**SUBDIVISION COMMITTEE  
METROPOLITAN AREA PLANNING COMMISSION**

**STAFF REPORT**  
**(Final Plat)**

**CASE NUMBER:** S/D 96-59 - MORGAN SHEET METAL ADDITION

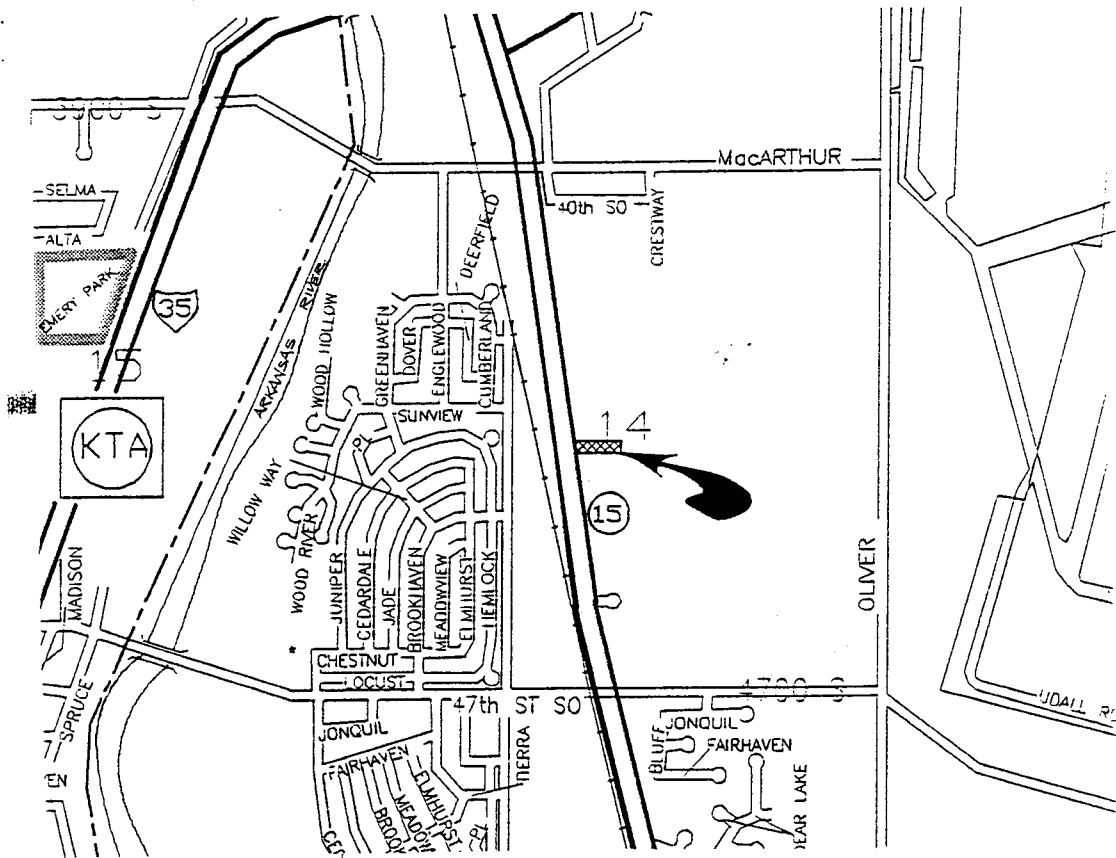
- A. The applicant's agent needs to indicate how this site (use) is presently being provided sanitary sewer service. County Engineering and/or County Health need to indicate, as appropriate to the existing situation, any requirements as to sewer service. It should be noted that this site is too small for a lagoon sanitary sewer system, and the use of a septic system also is quite questionable.

- B. The City Water Department and/or City Engineering need to indicate if any guarantees or other requirements such as an outside-the-City water agreement are needed for this plat.

- C. The applicant shall guarantee any drainage improvements required by the platting of this property.
- D. If improvements are guaranteed by petition, a notarized certificate listing the petitions shall be submitted to the Planning Department for recording.

- E. The final plat tracing shall indicate the platting of the 35-foot building setback from K-15 through the existing building which encroaches into the setback area. While the platting of this building setback does not preclude the property owner from maintaining or remodeling that portion of the building within the setback area. The building cannot, however, be enlarged within the setback and, if the building is removed, any new building construction must observe the platted building setback.

- F. The final plat shall reference a tie point to a previously platted lot corner or section corner.
- G. On the final plat tracing, the legal description shall be corrected to note "the south 110.4 feet..." (not fet).

- H. The applicant shall submit an avigational easement covering all of subject plat and a restrictive covenant assuring that adequate construction methods will be used to minimize the effects of noise pollution in the habitable structures constructed on subject property.

- I. The applicant shall install or guarantee the installation of all utilities and facilities which are applicable and described in Article 8 of the MAPC Subdivision Regulations. (Water service and fire hydrants required by Article 8 for fire protection shall be as per the direction and approval of the Chief of the Fire Department.)

- K. Perimeter closure computations shall be submitted with the final plat tracing. Section 5-101(c).
- L. Recording of the plat within 30 days after approval by the City Council and/or County Commission.
- M. The representatives from the utility companies should be prepared to comment on the need for utility easements to be platted on this property.
- N. The representatives from County Engineering should be prepared to comment on the status of the applicant's drainage plan.
